NEW HAMPSHIRE
DEPARTMENT OF PUBLIC WORKS AND HIGHWAYS
AND
STATE OF MAINE - DEPARTMENT OF TRANSPORTATION
INTERSTATE 95 BRIDGE
OVER
PISCATAQUA RIVER
BETWEEN
PORTSMOUTH, NEW HAMPSHIRE AND KITTERY, MAINE

STATE OF MAINE
DEPARTMENT OF TRANSPORTATION
☐ Approved ☒ Returned for Corrections
APR 12 1977
☐ Approved as noted
☐ Approved as noted - Resubmit ☐ Rejected
L. L. Roberts
ASST. BRIDGE DESIGN ENGR.

DESCRIPTION DRAIN EXTENSION LAYOUT
PROJECT I-95 PISCATAQUA RIVER BRIDGE
LOCATION PORTSMOUTH, N.H. & KITTERY, ME.
ARCHITECT N.H.D. of P.W.&H. / S. of M.D.O.T. / HARDESTY & HANOVER
CONTRACTOR CHERNAK-BREDBENNER CONSTR. INC.
PAINT
HOLES
DRAWN BY MARCO KM
CHECKED BY MARCO
DATE 2-1-77
PROJ. NO. 77-262
DRWG. NO. E1

DESCRIPTION TRUSS ELEVATION - DRAIN EXTENSION
PROJECT I-95 PISCATAQUA RIVER BRIDGE
LOCATION PORTSMOUTH N.H. & KITTERY, ME.
ARCHITECT N.H.D. of P.W. & H. / S. of M. D.O.T. / HARDESTY & HANOVER
CONTRACTOR CHERNAK-BREDBENNER CONSTR. CO.

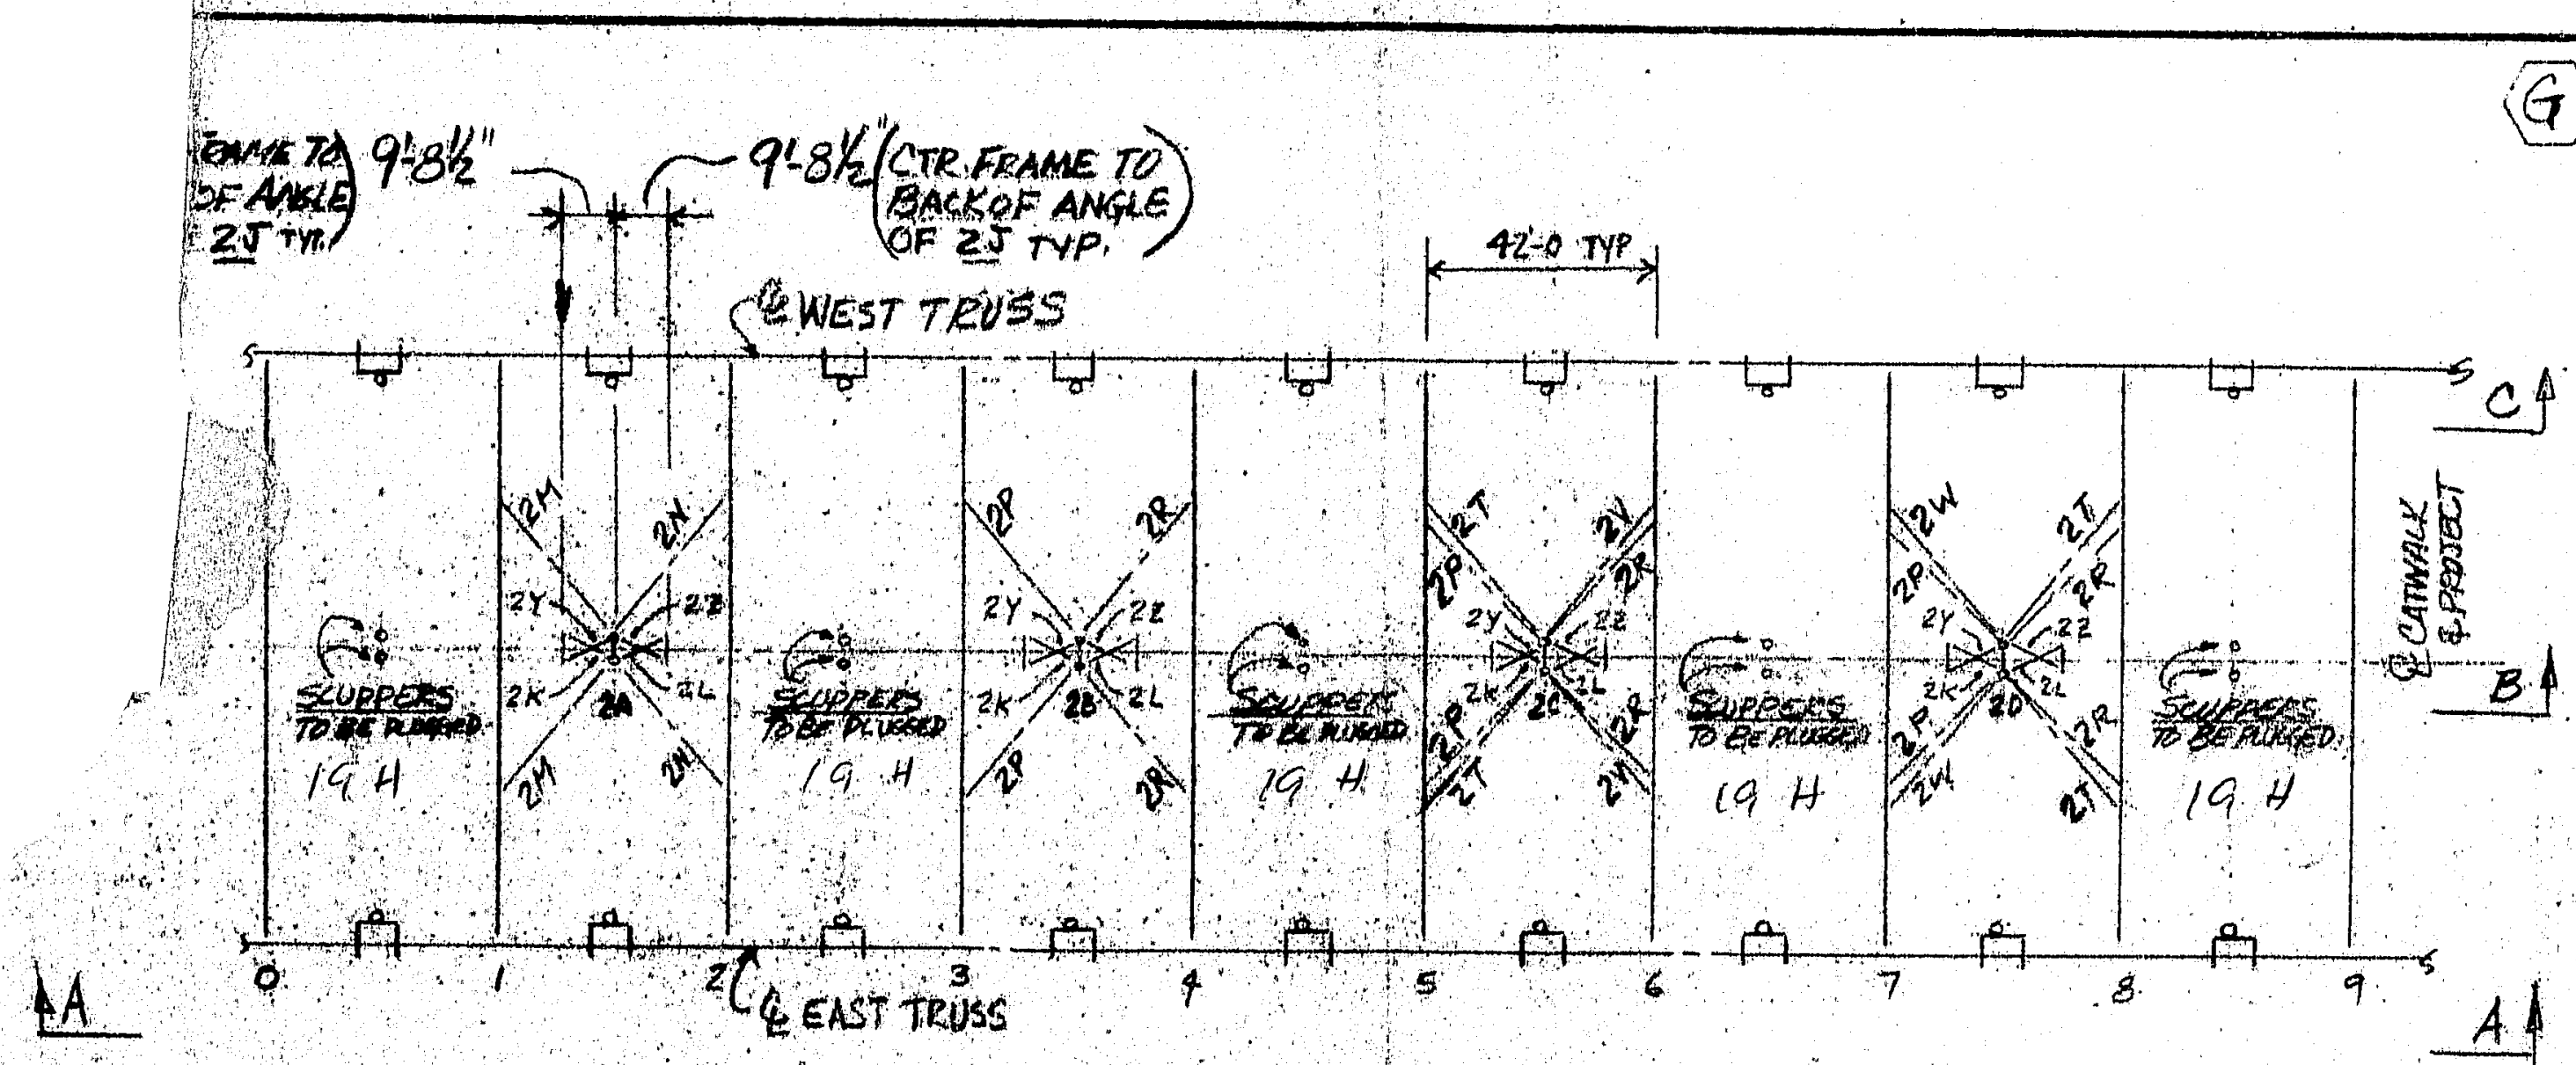
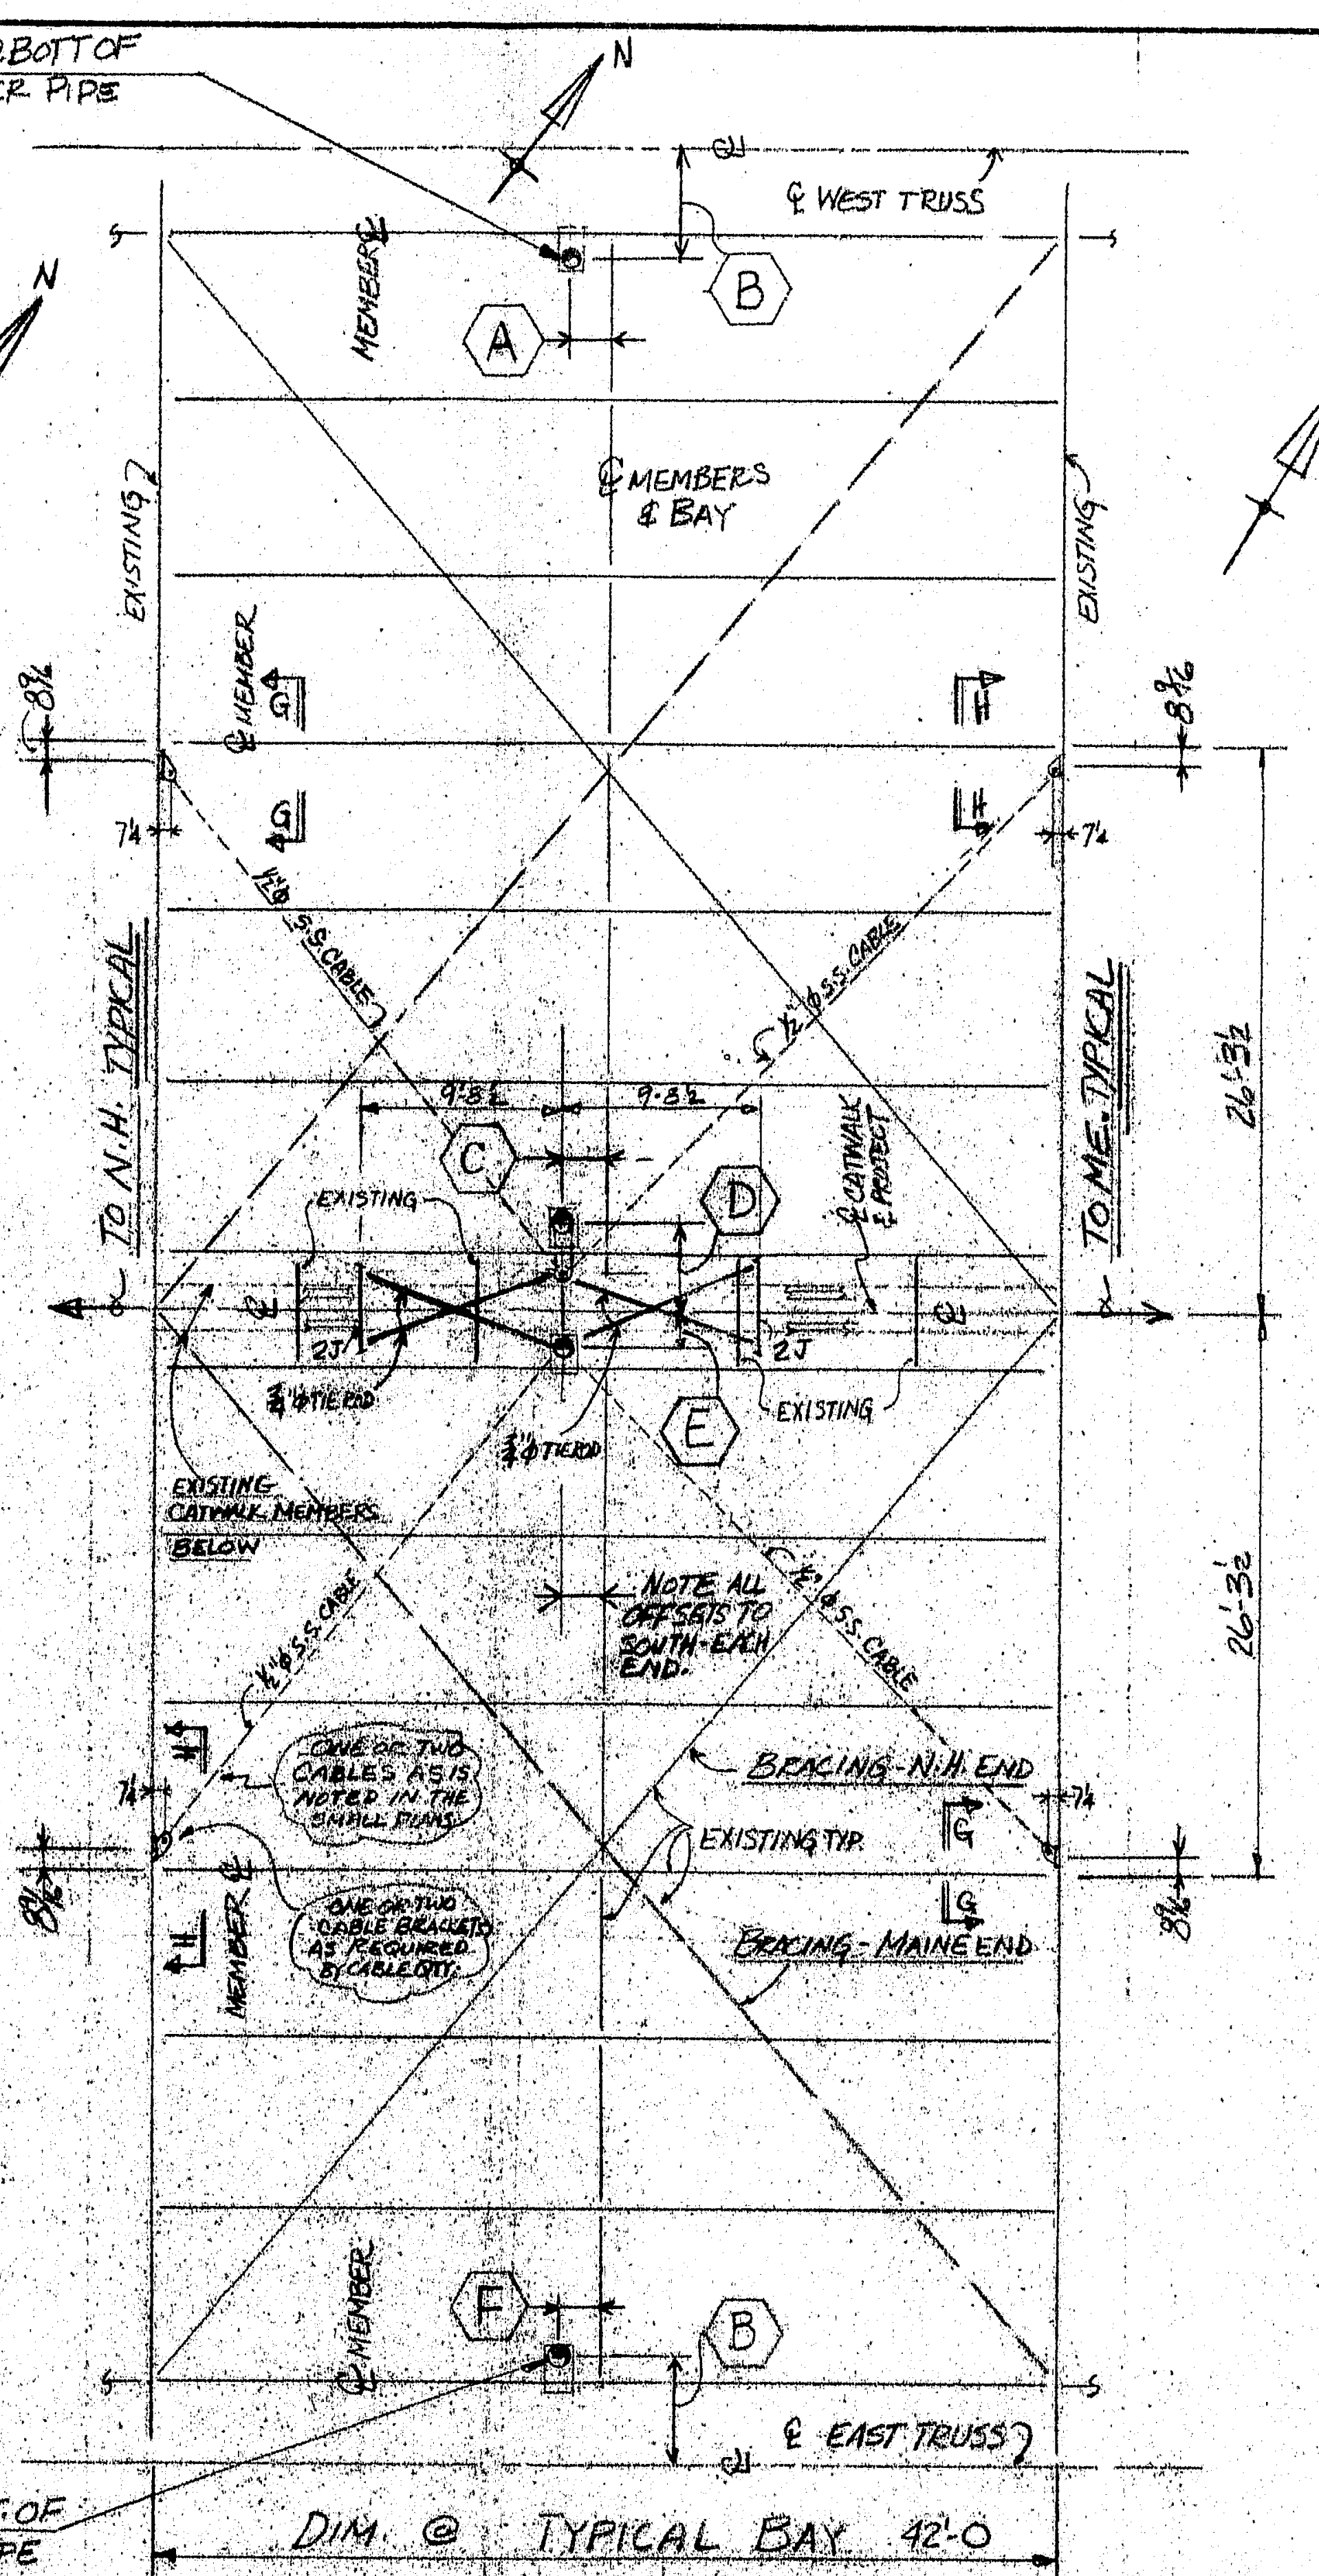
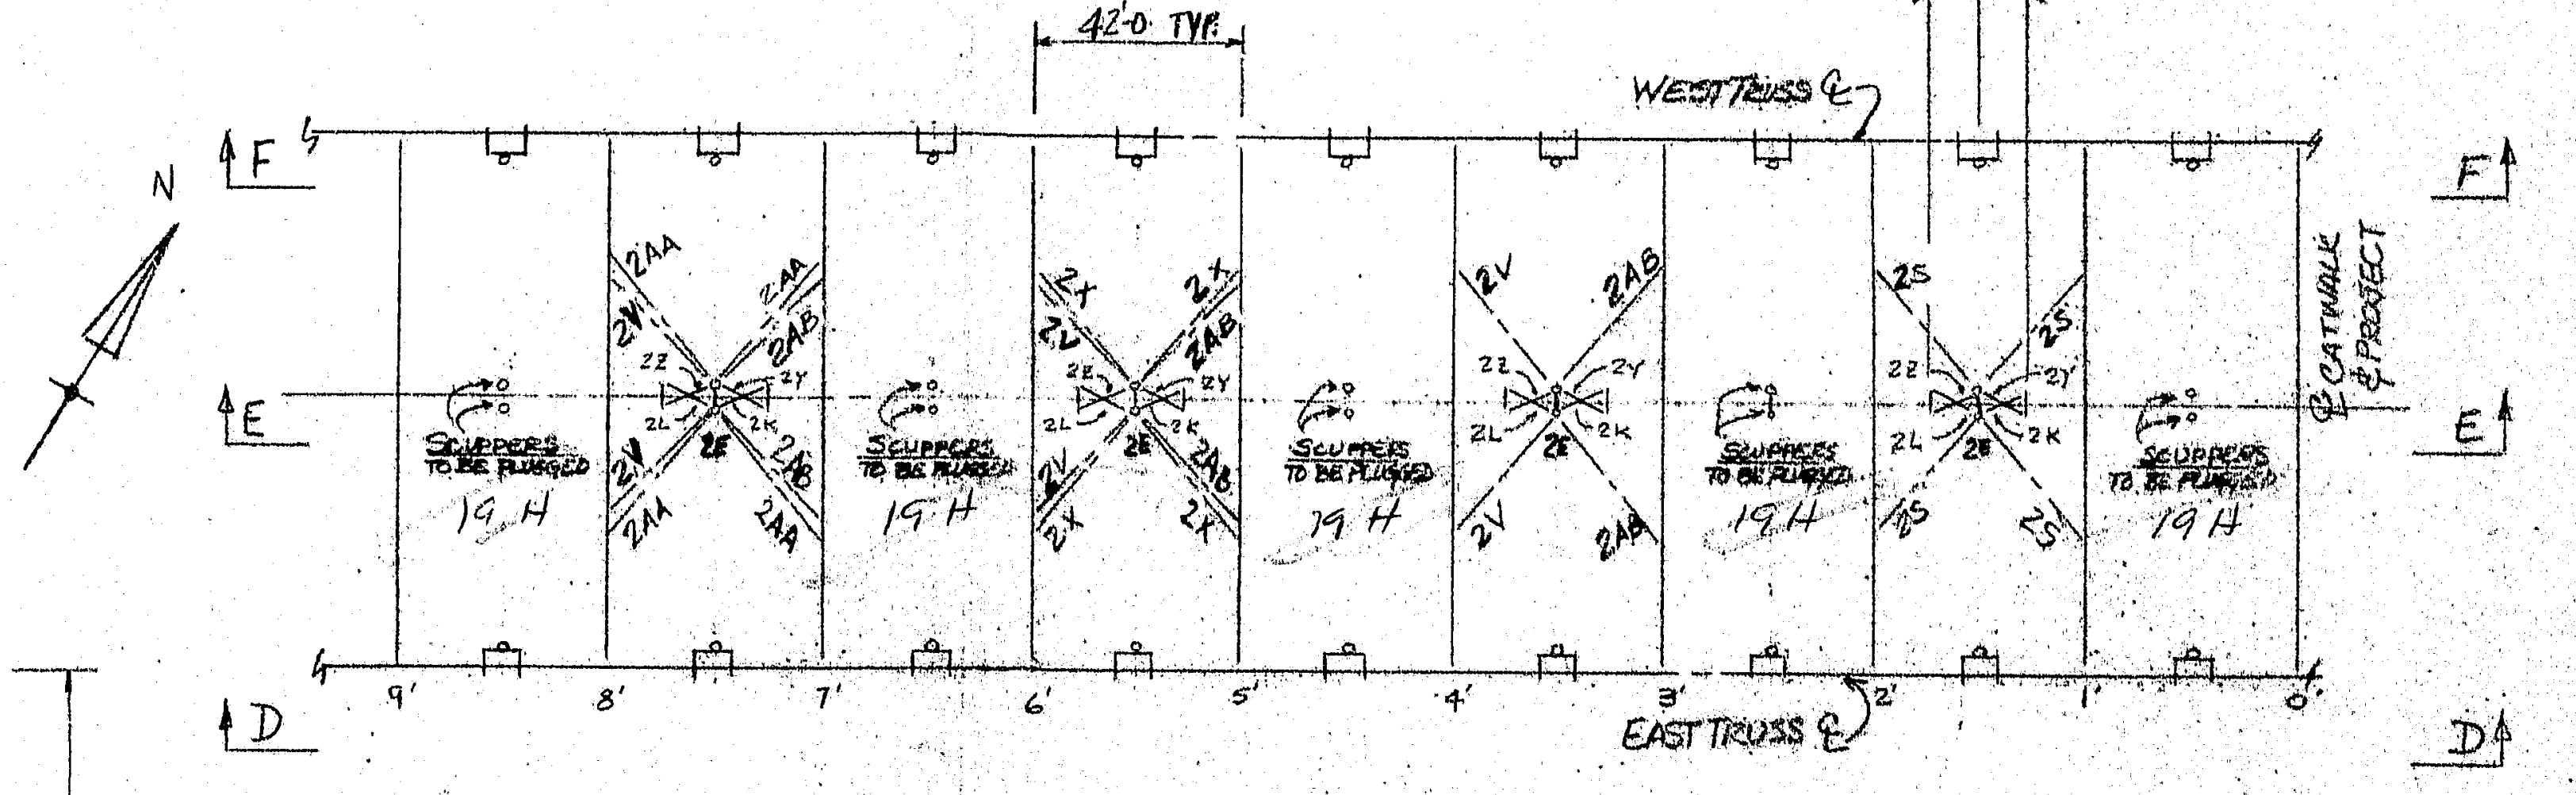
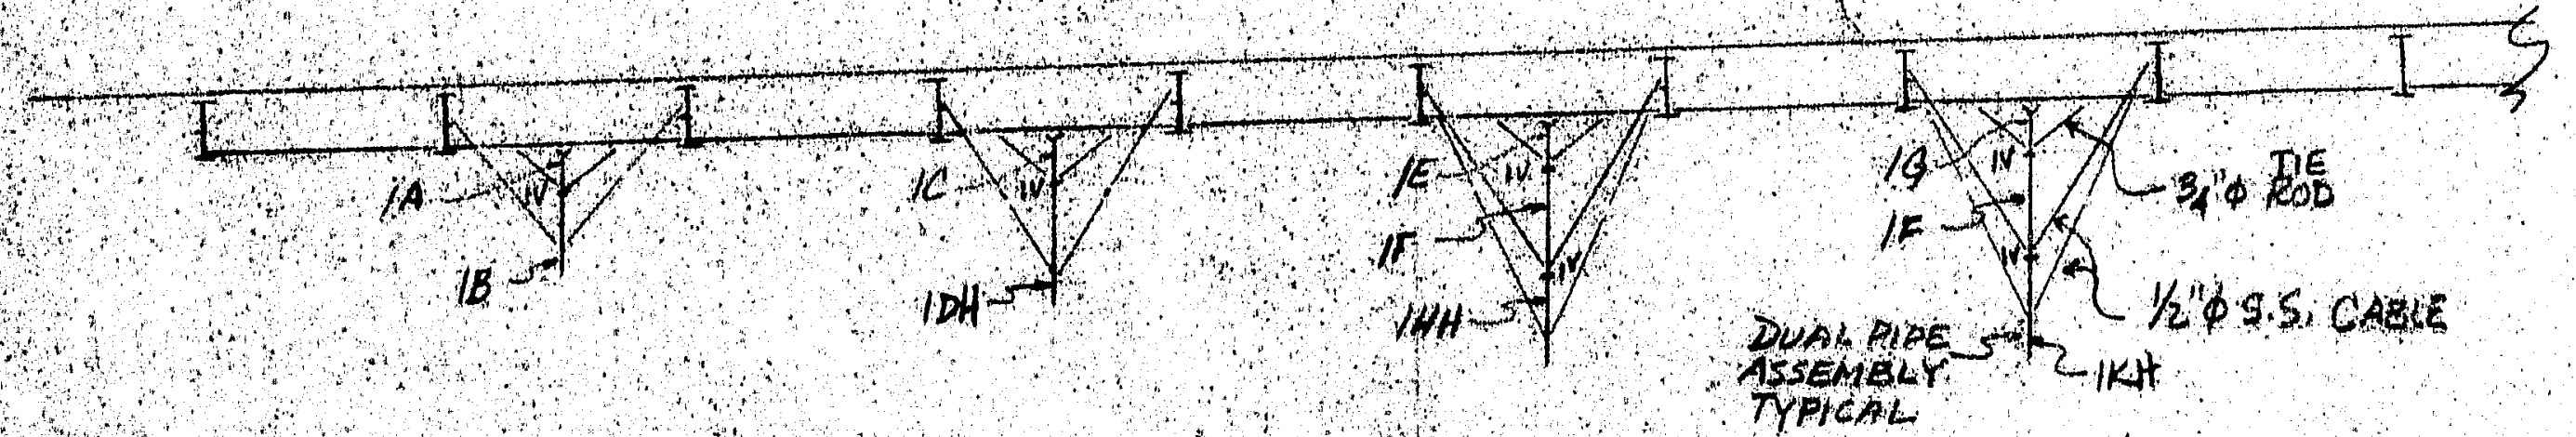
FIELD NOTE:
ALL DOWN SPOUTS TO BE HUNG PLUMB.
